LiDAR Quality Assessment Report

MS_Madison-Yazoo_2012

Lidar data was collected for an approximate 1,268 square mile area of Madison County and a portion of Yazoo County, Mississippi. This project was contracted by the Mississippi Department of Environmental Quality in support of FEMA's RiskMAP program. All elements of the project were to follow specifications of FEMA's Appendix A and Procedure Memorandum No. 61. An accuracy assessment was performed by Waggoner Engineering, Inc.

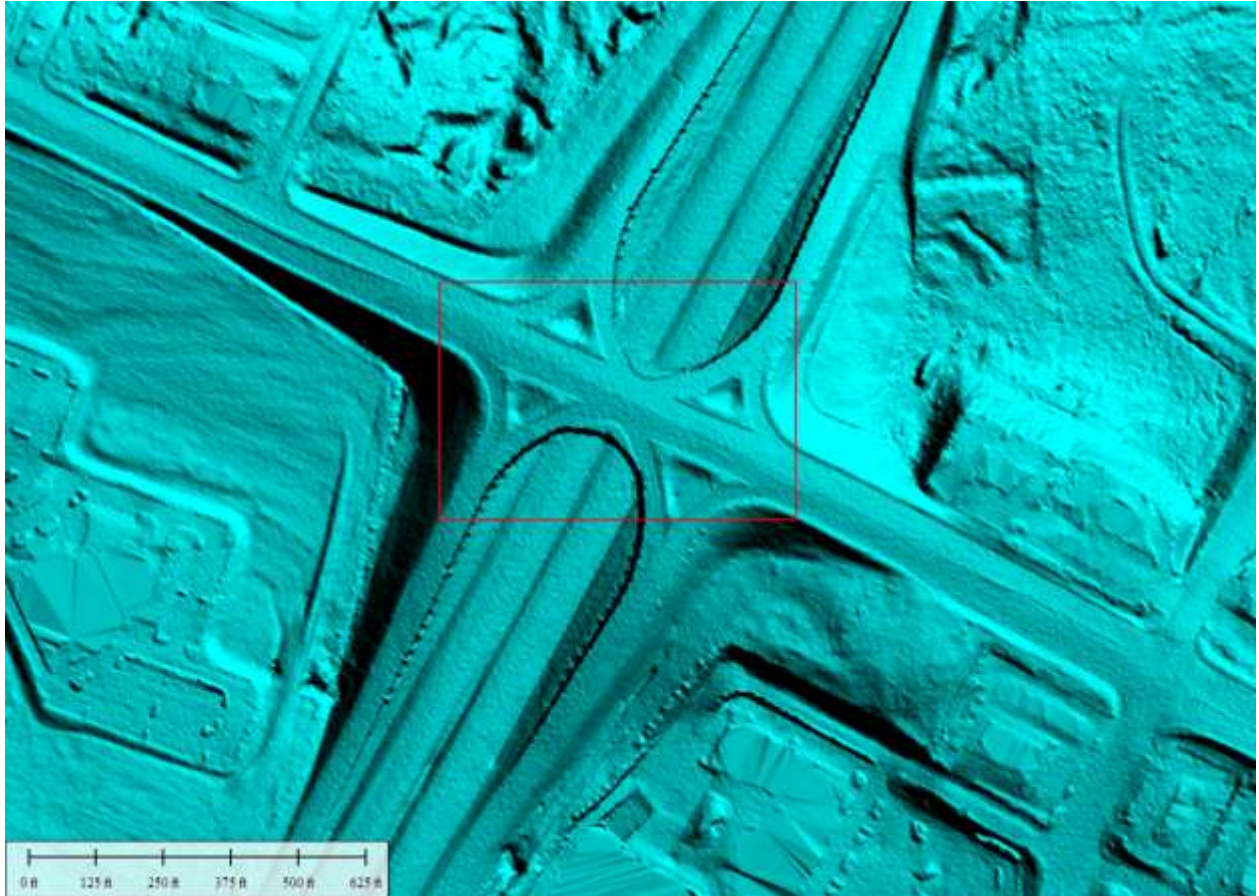
data_gap: This image shows a gap between three tiles...43_37, 43_38, and 44_38.

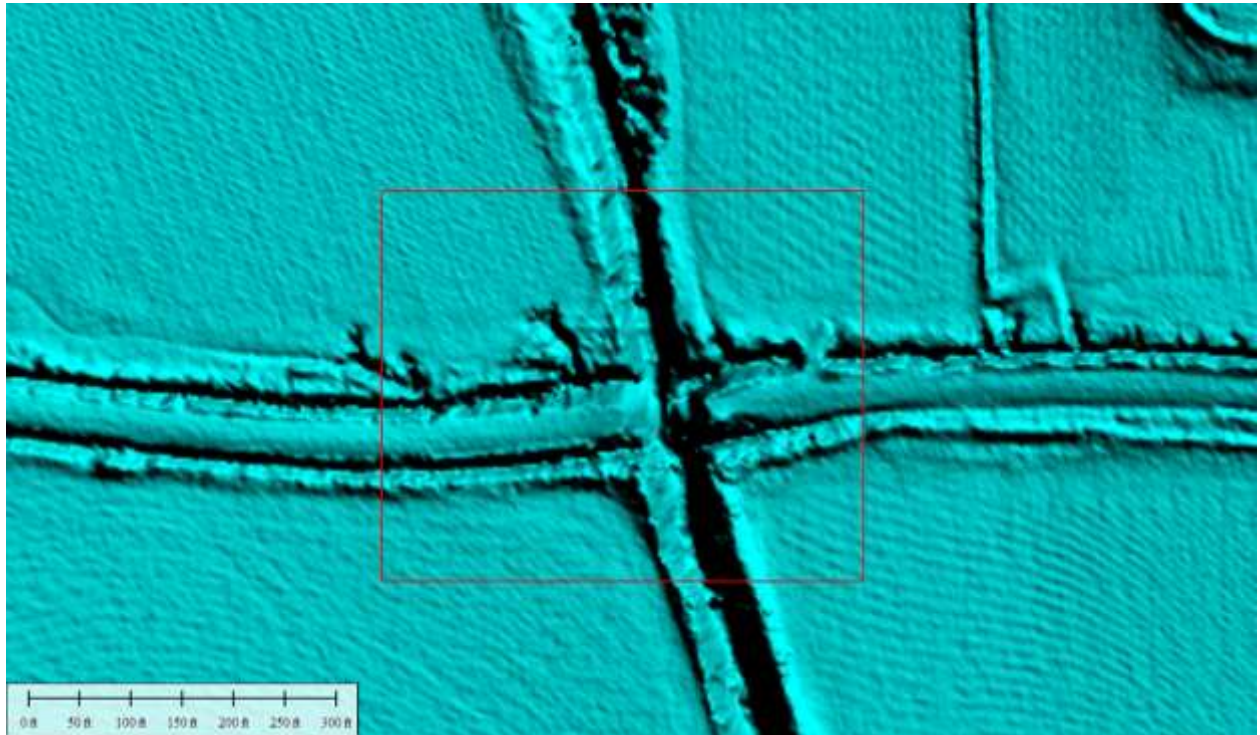
bridge_or_culvert: These structures are technically culverts and, thus, are not to be removed from the DEM. However, culverts spanning a distance greater than 20 ft. are often considered bridges. These
culverts
are greater than 50 ft. and should be removed from the DEM.

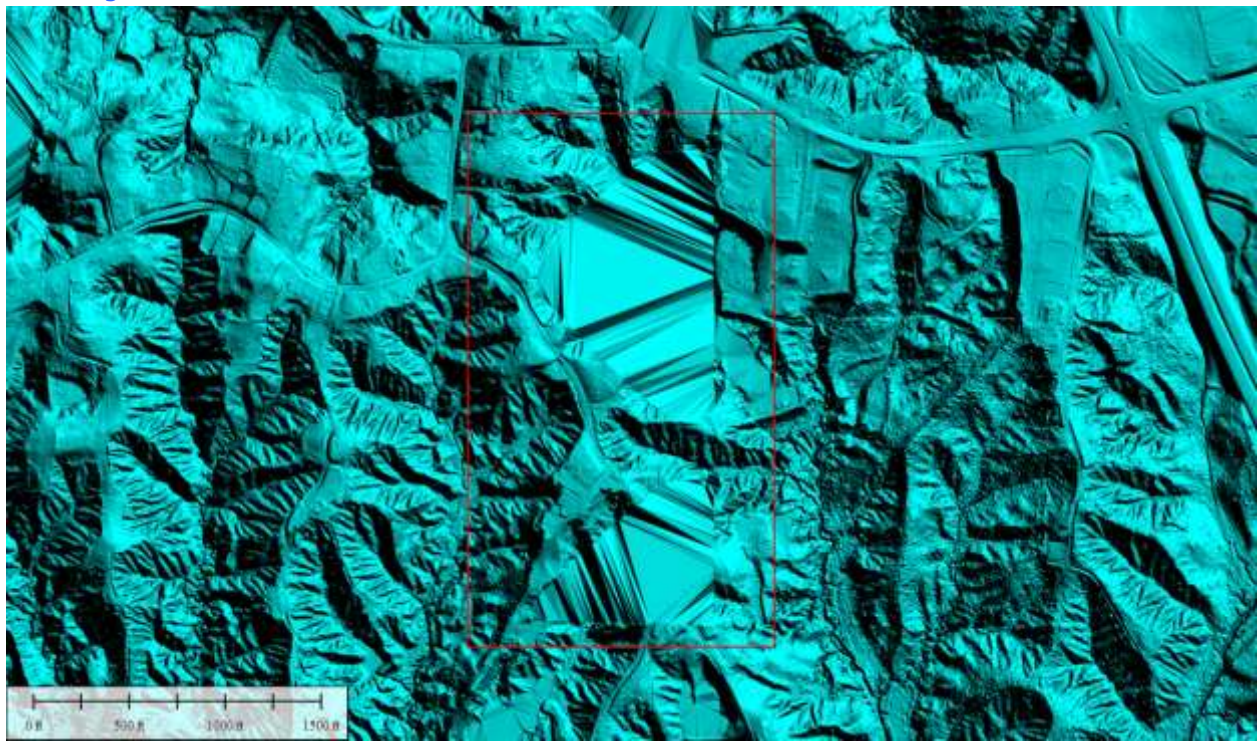
culvert_1: Roadway should not be removed over culverts. There are 17 of these error-types.

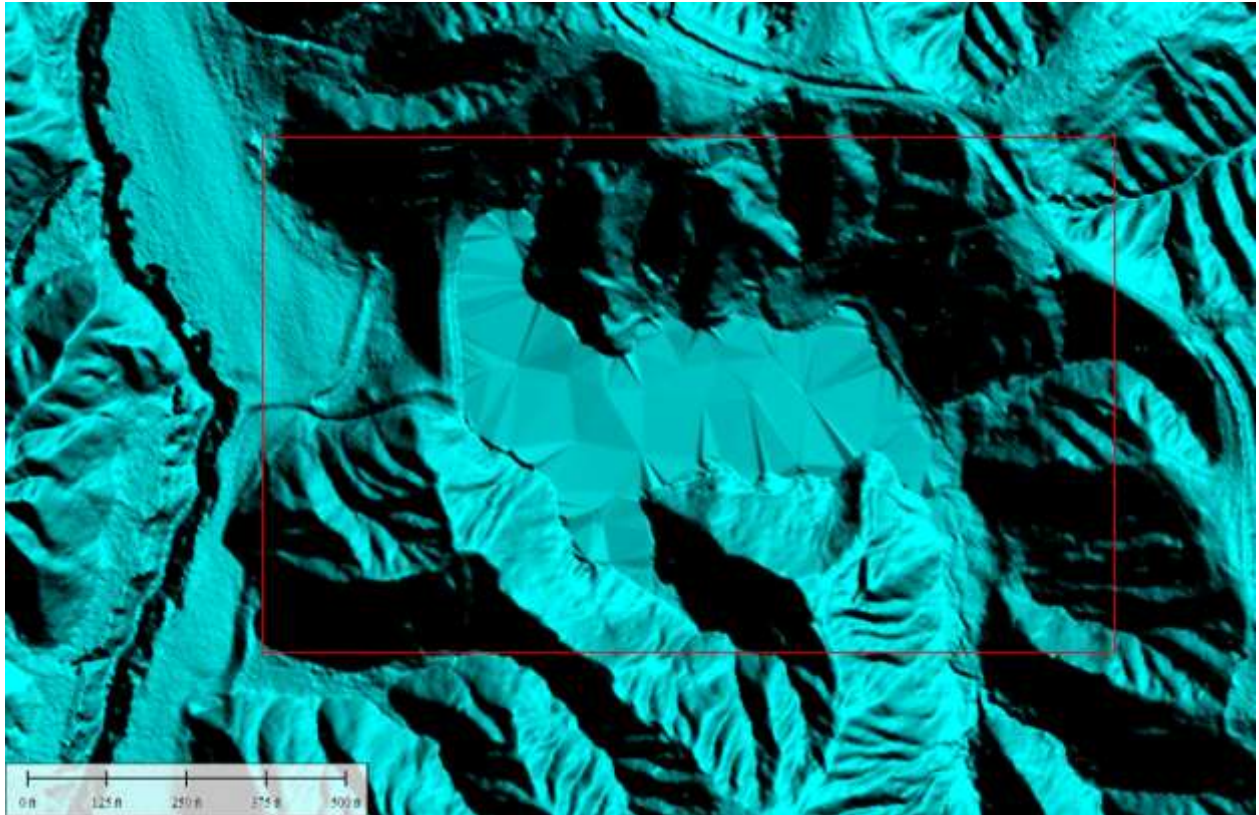
TIN_24: This image shows two areas of TINing. NAIP imagery shows a land-surface and not a waterbody under those areas. There are two of these error-types. The name of this error, TIN_24, suggests there are many of this error type; the others were either outside of the project boundary or are areas of swamp lands, which tend to TIN upon creation of the DEM... and are being pointed-out for reference only.
